**Comment Letter O5**

Re: Comments on the Draft Environmental Impact Report for the  
Jacumba Solar Project (PDS2014-MUP-14-041)  
(SCH No. 2014091034)

**Response to Comment Letter O5**

Figure 2. CNDDDB records of the southern grasshopper mouse in the vicinity of the Project site.

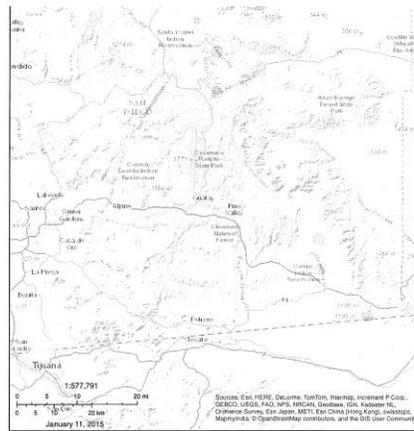
and fragmentation than other rodents.<sup>56</sup> As a result, any impacts to a subpopulation occurring on one of the Project sites would have relatively severe impacts to overall species viability and diversity. The DEIR failed to provide measures that ensure this potentially severe impact is mitigated.

Because trapping surveys were not conducted at the Project site, it is impossible for the public and decision makers to understand the Project's environmental setting and potential impacts, and the adequacy of the County's proposed mitigation measures.
